Access Compliance Report

Public Rights-of-Way

(Curb Ramps)

Intersection ID: 28155	Main Street: WAYLAND_DR	Cross Street: ROBSART_CT	Location: NW
ADA ID: 3BF59AE3F726	Ramp Type: PerpDiag	Initial Pass/Fail: Fail	Overall Compliance: No
Severity Score: 37.5			
Codes/Mitigation Info/Possible Solution		Field Measurements/Component Compliance

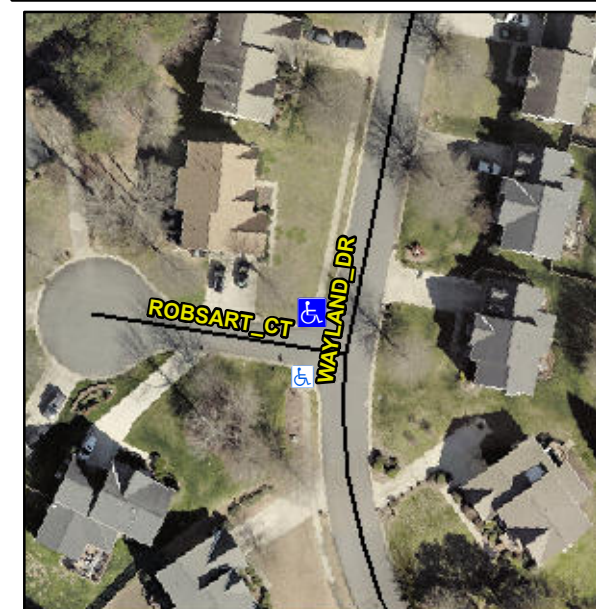
R304.2.2, R304.5.3

Compliance	Description	Data	Compliance	Description	Data
N/A	Ramp Length (in)	93.0	No	Ramp Slope (%)	9.4
Yes	Ramp Width (in)	48.0	No	Ramp XSlope (%)	8.8
N/A	Flare Type LT	N/A	N/A	Flare Type RT	N/A
N/A	Flare Slope LT (%)	N/A	N/A	Flare Slope RT (%)	N/A
N/A	Flare Traversable LT?	N/A	N/A	Flare Traversable RT?	N/A
N/A	Landing Length (in)	N/A	N/A	DWS Provided?	N/A
N/A	Landing Width (in)	N/A	N/A	DWS Contrast?	N/A
N/A	Landing Slope (%)	N/A	N/A	DWS Length (in)	N/A
N/A	Landing X Slope (%)	N/A	N/A	DWS Full Width?	N/A
N/A	Landing Curb? (Y/N)	N/A	N/A	DWS Offset (in)	N/A
N/A	Shared Landing?	N/A			
N/A	Gutter Ponding?	N/A	N/A	Gutter Slope (%)	N/A
N/A	Gutter Lip Ht (in)	N/A	N/A	Gutter X Slope (%)	N/A
N/A	Painted X Walk1?	No	N/A	Painted X Walk2?	No
	X Walk 1 Direction	To S		X Walk 2 Direction	To E
N/A	X Walk 1 Width (in)	N/A	N/A	X Walk 2 Width (in)	N/A
	X Walk 1 Slope (%)	0.6		X Walk 2 Slope (%)	4.8
	X Walk 1 X Slope (%)	5.7		X Walk 2 X Slope (%)	3.9

Remove & Replace Curb Ramp With Two New Directional Ramps or Equivalent.
